CANAL SUBDIVISION

APPLICATION NUMBER 14 DATE October 15, 2009

REQUEST Subdivision

DETAIL SITE PLAN

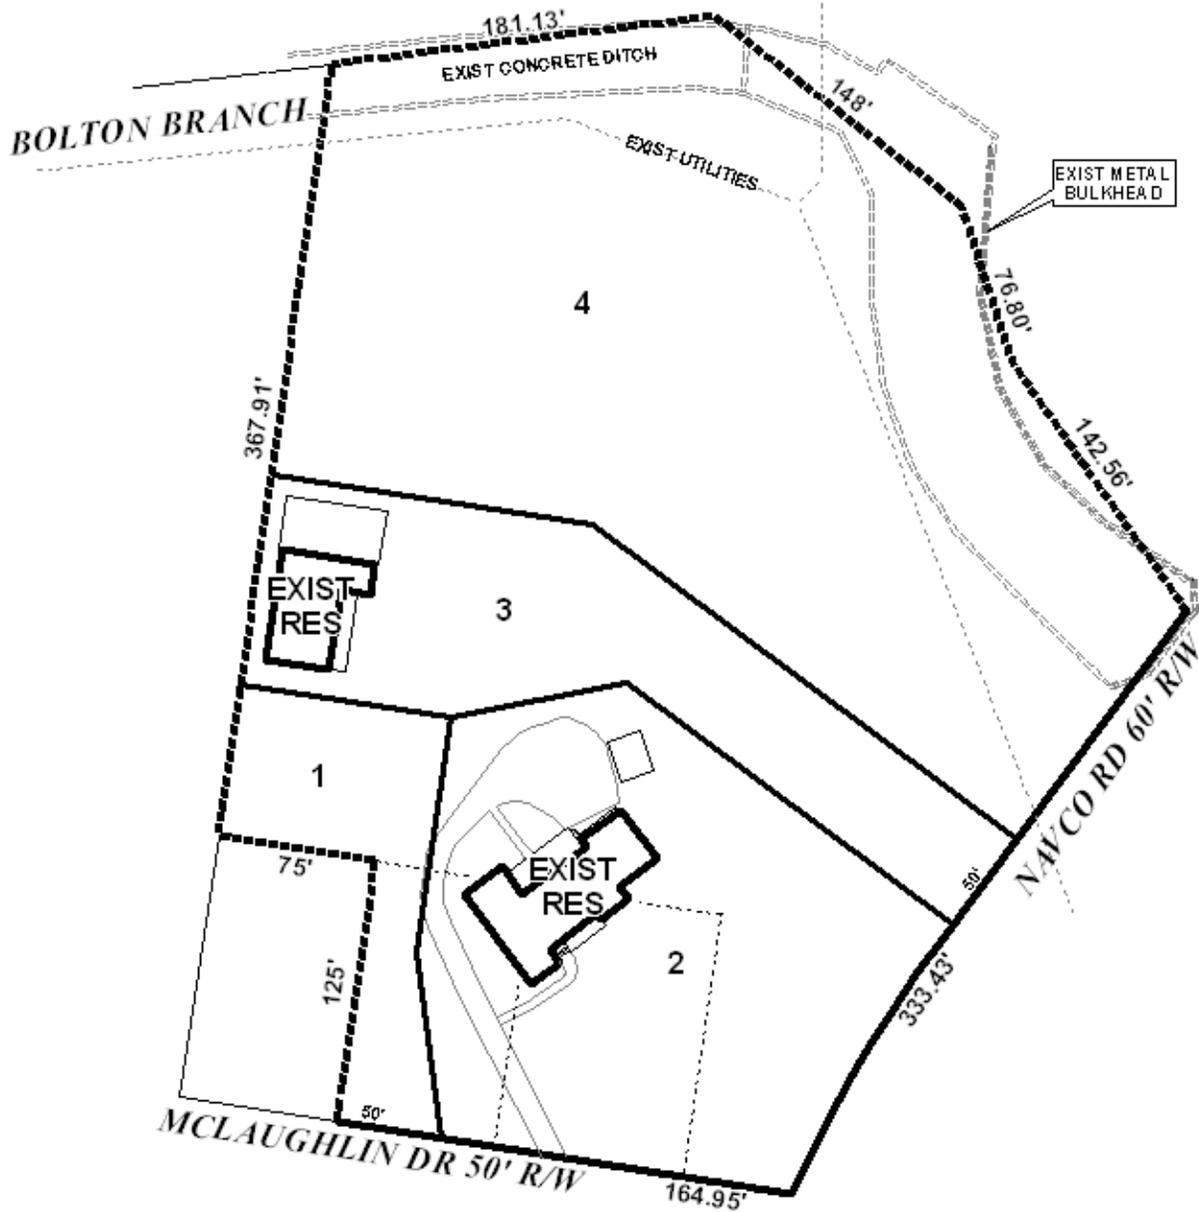
The proposed subdivision fronts Navco Road and McLaughlin Drive. McLaughlin Drive currently has a compliant 50' right-of-way. However, Navco Road currently has a 60' right-of-way along the property and is a component of the Major Street Plan with a planned 100' right-of-way. Therefore, dedication would be required along Navco Road to provide 50' from the centerline of Navco Road. Dedication would also be required to provide a 25' radius corner at

the Northwest corner of Navco Road and McLaughlin Drive. As a means of access management, a note should be required on the final plat stating that Lots 1 and 2 are limited to one curb cut each to McLaughlin Drive, and Lots 3 and 4 are limited to one curb cut each to Navco Road, with the size, location, and design to be approved by Traffic Engineering and conform to AASHTO standards. Each lot should be labeled on the final plat with its size in acres and square feet, or a table should be furnished on the final plat providing the same information.

With regard to the configuration of the proposed lots, Lot 1 would be a flag lot. Section V.D.1. of the Subdivision Regulations states “Panhandle or flag lots shall generally not be allowed, but may be permitted only in those locations where varied and irregularly-shaped lot designs are common and the informality of design is consistent with other lots in the vicinity; or, where unusual circumstances such as an odd shaped lot exists; or, separate disparate uses exist on a single lot; or, where there are natural or pre-existing man-made barriers which may cause an undue hardship on the land owner; or in the case of a family division. Requests for panhandle or flag lots shall be accompanied by evidence showing that each panhandle or flag lot is necessary to allow the site owner reasonable use of the site or to alleviate a situation that would otherwise cause extreme hardship.” No justification for the flag lot has been presented by the applicant and the surrounding residential neighborhoods do not contain flag lots. Therefore, the proposed lot would be out of character with the existing configurations in the neighborhood.

Proposed Lot 3 would exceed the maximum 3.5 depth-to-width ratio of Section V.D.3. of the Subdivision Regulations and would be of irregular shape. As there are no other similar recorded lots within the surrounding residential neighborhood, proposed Lot 3 would also be out of character with existing lot configurations. Due to its location in relation to Lot 4 and the drainage canal, with modifications Lot 3 could be made a viable lot if 60’ of frontage were to be provided along Navco Road.

- 1) Lot 1 does not meet the criteria to justify its flag lot shape and would be out of character with the existing residential lot configurations in the surrounding residential neighborhood; and
- 2) Lot 3 would be out of character with existing residential lot configurations within the surrounding residential neighborhood; and
- 3) Compliance with Engineering comments: *(Label each Lot showing the required minimum finished floor elevation (MFFE). It appears that Lots 2, 3 & 4 are located in*
